ADDENDUM NO. 1

August 3, 2023

Geiger House
2631 Gilbert Avenue
Cincinnati, OH 45206

Emboss Design (formerly PCA)
906 Monmouth Street
Newport, KY 41071

SHEET TITLE GRADING & UTILITY PLAN	
DESIGNED S.C.S.	JOB NO.
DRAWN F.O.S.	SHEET NO.
CHECKED S.C.S.	C-03
DATE November 2022

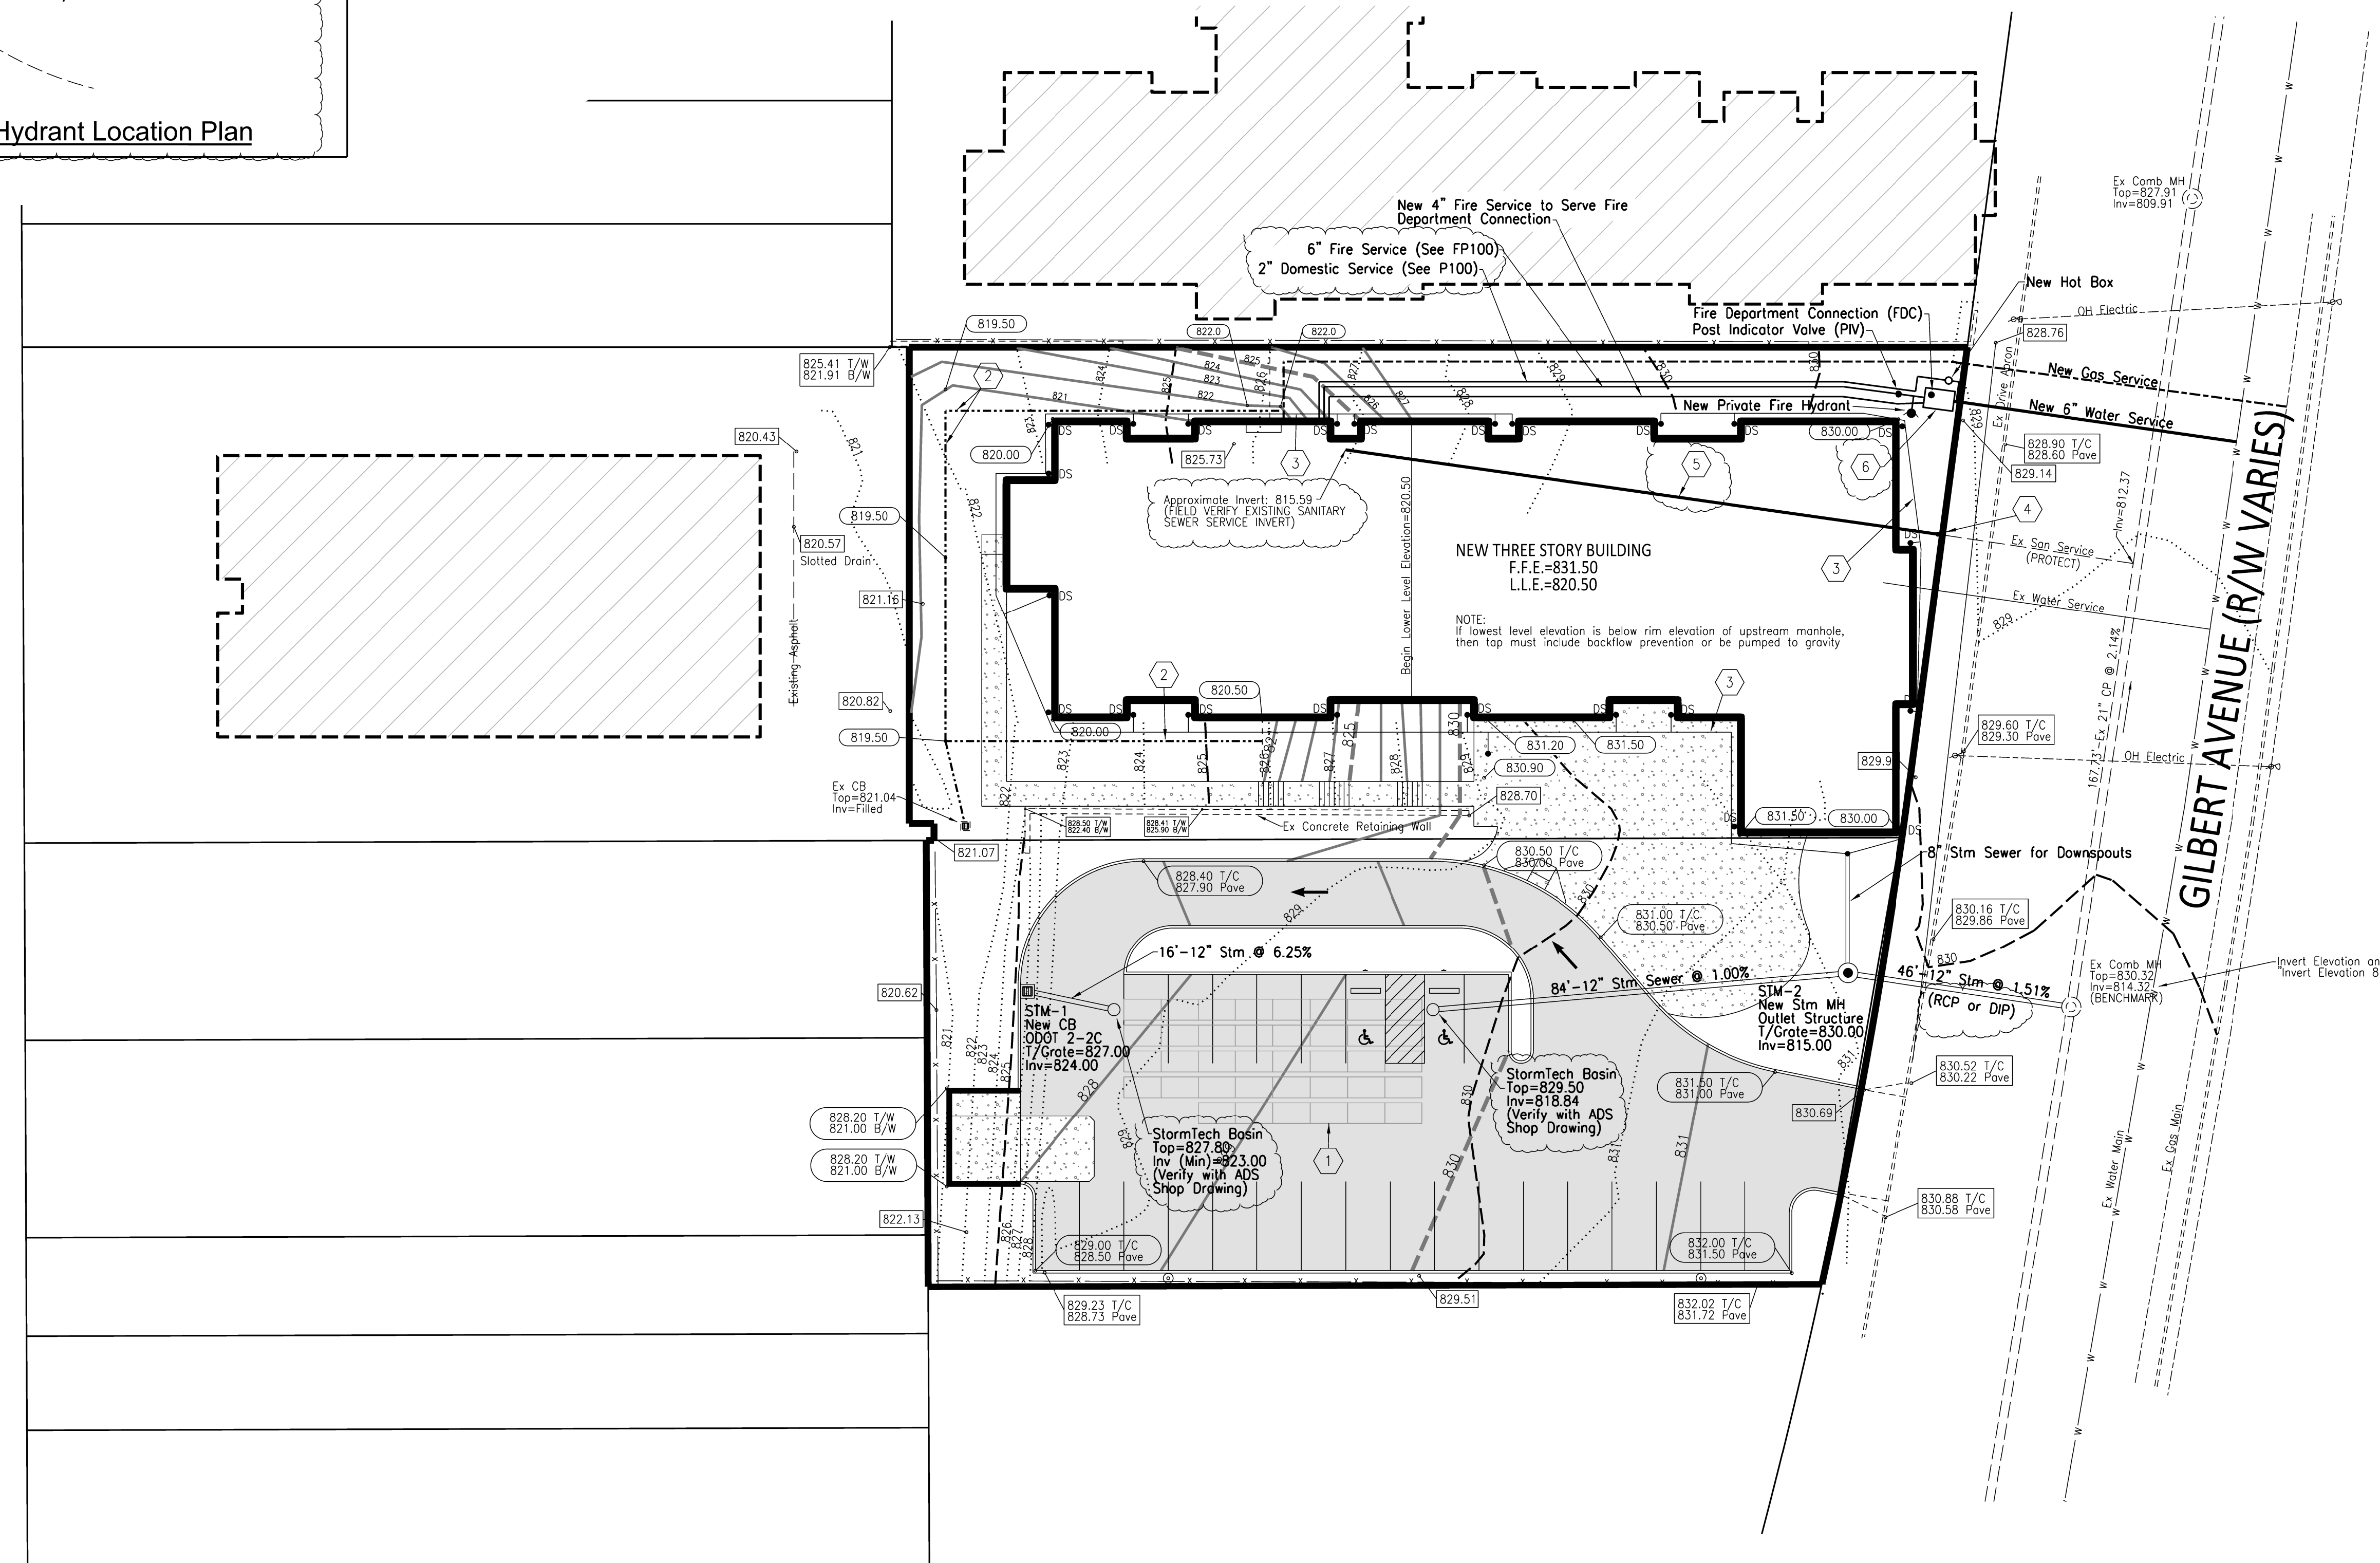
1. C-03 GRADING & UTILITY PLANS

- Added top elevations and invert elevations to sheet for various pipes and structures
- Added note for size of new water line
- Added note for hot box
- Revised notes for sizes and lengths of various pipes
- Added note clarifying RCP or DIP for storm sewer pipe

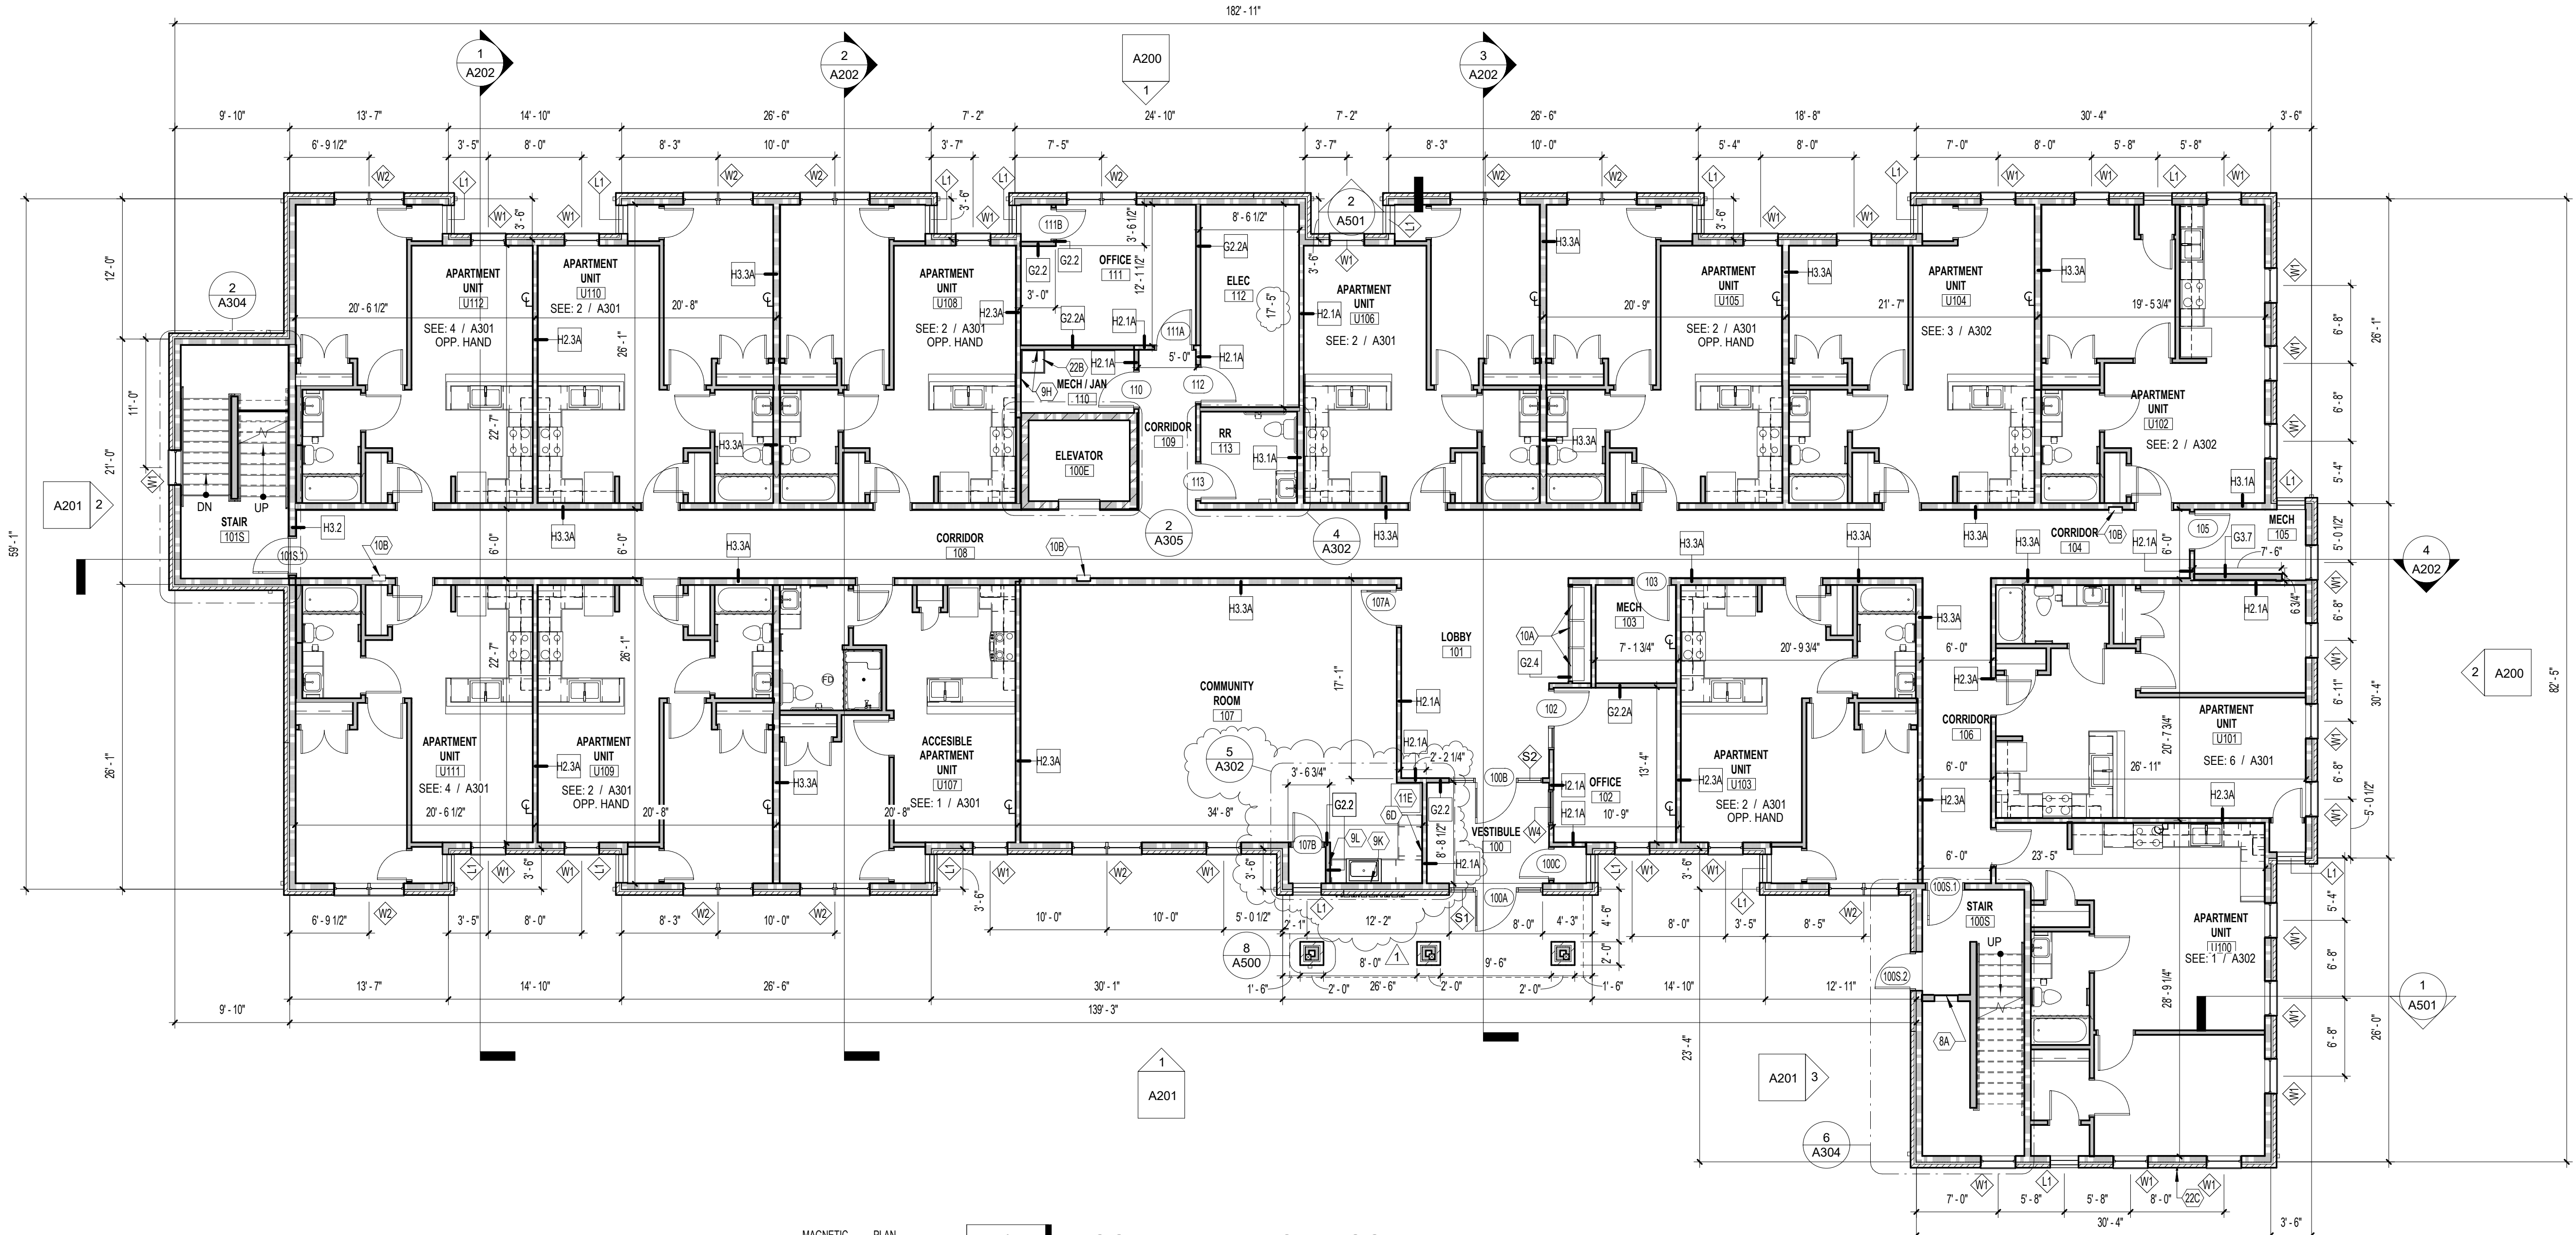
3. A101 FIRST FLOOR PLAN

- Removed window W2 previously shown behind sink in Community Room 107
- Revised sink type in RR 113 and enlarged room 3 ¾" to the North
